**Monks Orchard Residents' Association
Planning**

| Appeal Reference: | APP/L5240/W/23/3327704 |
| Address: | 13 Gladeside, Croydon, CR0 7RL |
| Proposal: | Demolition of the existing detached dwelling and erection of 3 no. dwellinghouses with parking, cycle stores and private amenity, and associated works. |

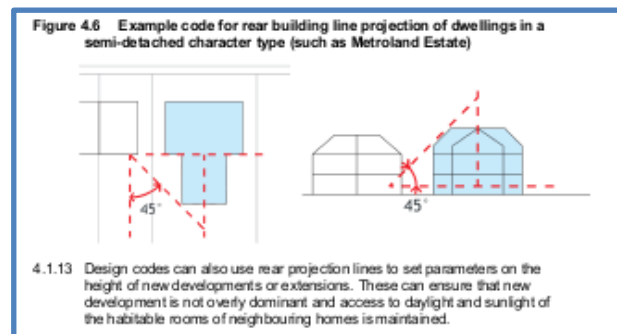
- 6.26 The rear building line of the proposed dwelling closest to No. 11 Gladeside would project 7.25m beyond that of the neighbouring property. The 45-degree BRE line has been applied on plan form, and it demonstrates that the proposal would not comply with this guideline. While it's noted that this is not complied with in its current form, the 45-degree line is breached in relation to the conservatory that exists to the rear of No. 13. The Design and Access Statement sets out that the nearest window at first floor of No. 11 is not a habitable room, however, this does not take into account the ground floor window, which would also be impacted. It is considered that the massing of the proposal, specifically, the depth of the projection would have an adverse impact on No. 11 Gladeside, in terms of having an overbearing presence which would result in a sense of enclosure.

- It is worth noting that 7-13 Gladeside are staggered. 13 Gladeside sits 3.3m beyond the rear elevation of no. 11, as does no 9 from 7. The design follows the existing staggered build pattern. This pattern also continues and is even more pronounced between 15-21 Gladeside, with the rear elevation being set back 8.3m from the neighbouring dwellings; more than the 7.25m we have proposed.
- The 45-degree BRE assessment the planning officer has made is inaccurate. The 45-degree BRE line is to be taken from the nearest habitable room window. The closest window on the first floor is a bathroom whilst the closest window on the ground floor is a kitchen, neither of which are considered habitable rooms. As such, the design meets policy and does not intersect with the 45-degree line. If the planning officer had attended a site visit, this would have become apparent.
